**JD-6 Mine Permit Amendment
Permit File No. M-1977-310**

Response to Adequacy Review

JD-6 Mine, File No. M-1977-310, Amendment (AMI) Application Adequacy Review

JD-6 Mine Vent Locations (2)

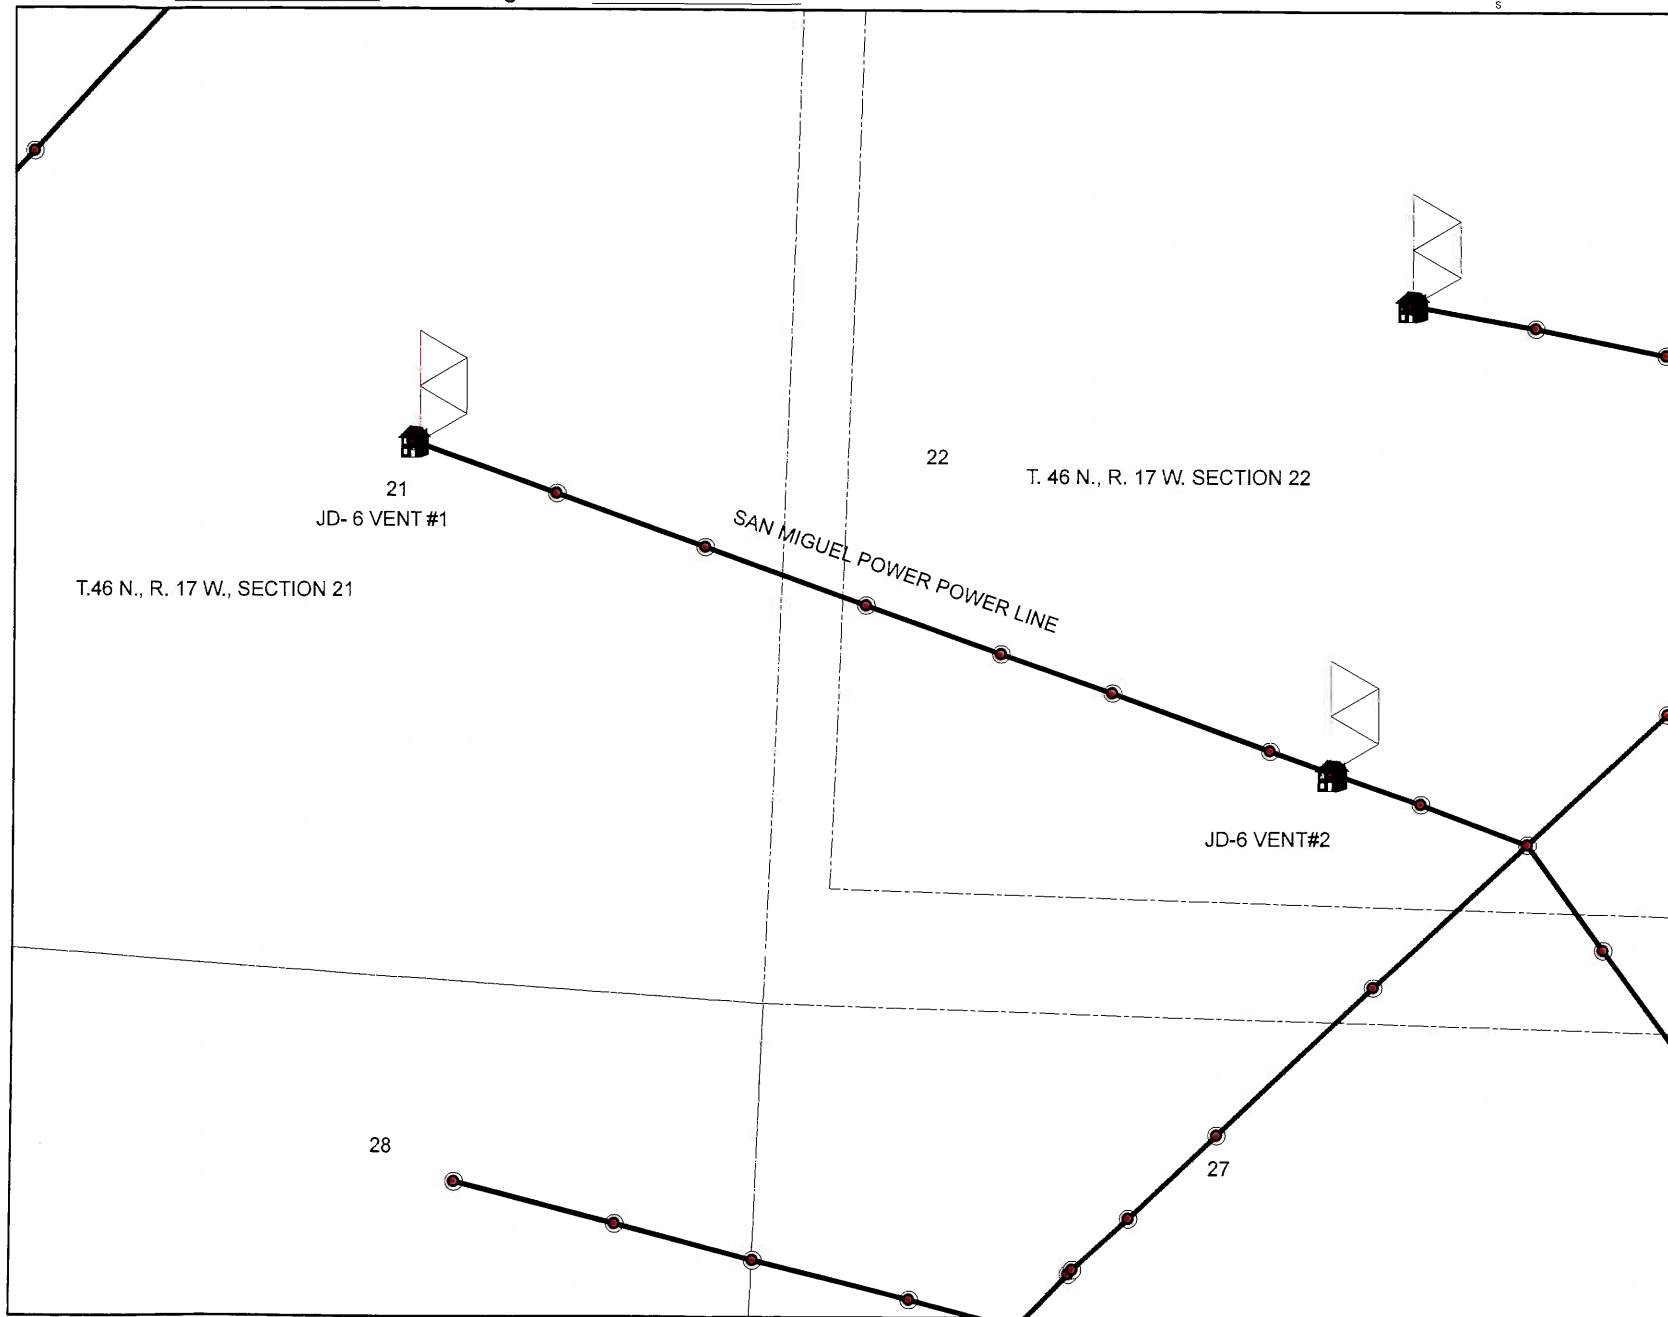
3. *Addressing Rule 6.3.12 - The mine plan proposes to utilize power supplied by a San Miguel Power Association. Please submit to the Division, either a notarized agreement between Cotter Corp. and SMPA, that Cotter Corp. is to provide compensation for any damage to the power line caused by the mining operation, or a notarized letter, from SMPA on their letterhead, that the proposed mining and reclamation activities will have "no negative effect" on their power line.*

A copy of the agreement between Cotter Corporation and SMPA is included as Attachment 1.

This Agreement entered into between Cotter Corp. and San Miguel Power Association, Inc., provides that Cotter Corp. agrees to provide compensation for any damage to the San Miguel Power Association, Inc., power lines caused by the mining operations at the JD-6 Mine. This damage agreement is entered into to comply with Rule 6.4.19 of the Colorado Mined Land Reclamation Board regulations dealing with any adverse affect on any significant, valuable or permanent man-made structure located within 200 feet of the affected land. (See attached map)
